Access Compliance Report Public Rights-of-Way (Curb Ramps)

Main Street: CHAPMAN_AVE Cross Street: ORANGE_PARK_BLVD Location: SW

ADA ID: RPAT210927091805 Ramp Type: Type 4 - Parallel Initial Pass/Fail: Fail Overall Compliance: No Severity Score: 16

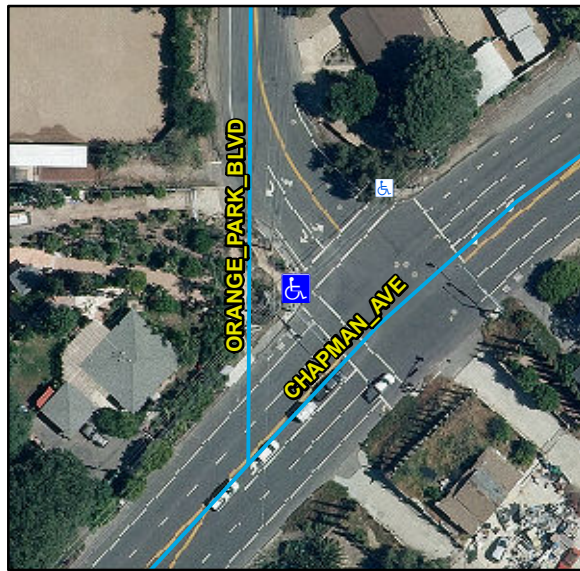
Compliance	Description	Data	Compliance	Description	Data
N/A	Ramp Length LT (in)	48	N/A	Ramp Length RT (in)	48
Yes	Ramp Width LT (in)	48	Yes	Ramp Width RT (in)	48
Yes	Ramp Run Slope LT (%)	5.7	Yes	Ramp Run Slope RT (%)	7.1
No	Ramp Cross Slope LT (%)	4.5	No	Ramp Cross Slope RT (%)	3.9
N/A	Landing Present	N/A	N/A	DWS Provided	N/A
N/A	Landing Length (in)	N/A	N/A	DWS Contrast	N/A
N/A	Landing Width (in)	N/A	N/A	DWS Length (in)	N/A
N/A	Landing Run Slope (%)	N/A	N/A	DWS Full Width	N/A
N/A	Landing Cross Slope (%)	N/A		DWS Offset Type	N/A
N/A	Landing Movement Obstructed?	N/A	N/A	DWS Offset Left (in)	N/A
	Landing Movement Type	N/A	N/A	DWS Offset Right (in)	N/A
N/A	Landing Shared	N/A			
N/A	Clear Space	Yes			
N/A	Clear Space To Crosswalk (in)	48			
N/A	Marked Crosswalk 1	Yes	N/A	Marked Crosswalk 2	Yes
	Crossing 1 Direction	N		Crossing 2 Direction	E
	Marked Crosswalk 1 Width (in)	120		Marked Crosswalk 2 Width (in)	120

Remove & Replace Curb Ramp With Two New Directional Ramps or Equivalent.

R304.5.3, R302.7, STD 1115
